Government of the District of Columbia  
**Advisory Neighborhood  
Commission 6C**

Re: ZC 18-16, 19-27, 19-27A, & 19-27B (Rulemaking)

Re: Defective Zoning Administrator Interpretation of 11-E § 206 (Rooftop Elements)

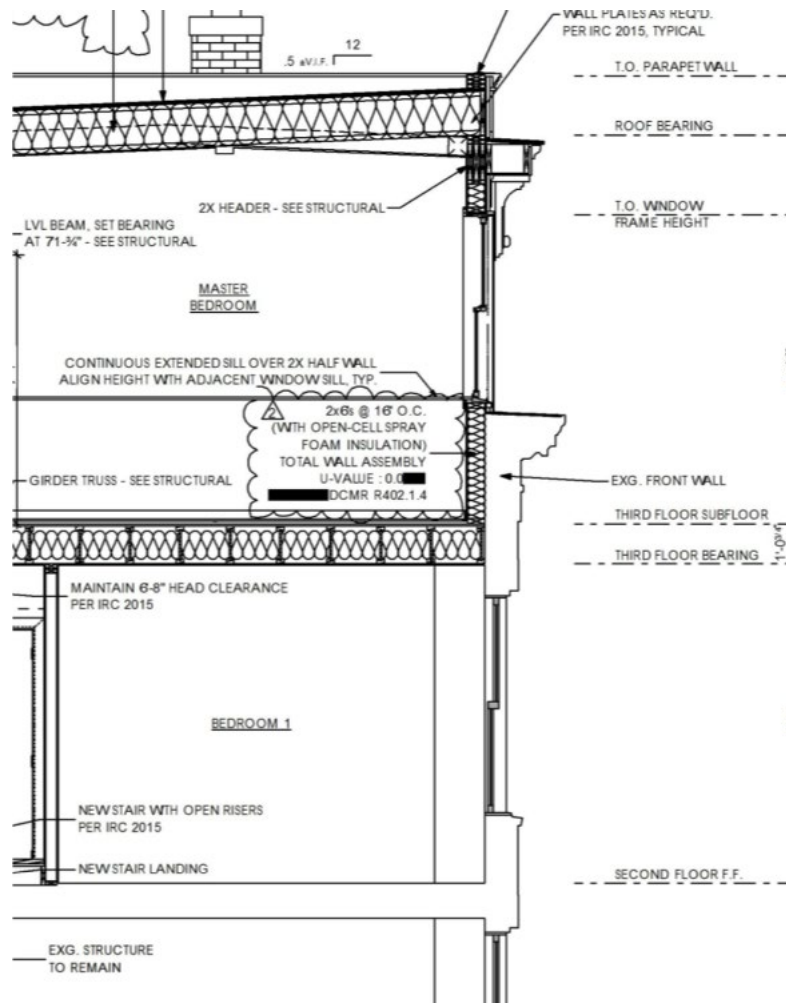
In early March, however, I observed new construction in my SMD where the upper-story addition has zero setback:

The underlying permit drawings confirm that DCRA approved this configuration:

I promptly wrote to the ZA, expressing my concern that this is not in keeping with section E-206. As shown in his response (copy attached), the ZA asserts that his setback rule does not apply to cornices. (No such distinction is suggested in the text of ZA-007.)

The ZA's position is deeply problematic for two reasons. The first, purely esthetic reason is that allowing such construction diminishes the visual impact of the original cornice. That is especially true where, as in the drawing above, a new cornice is proposed for the top of the addition.
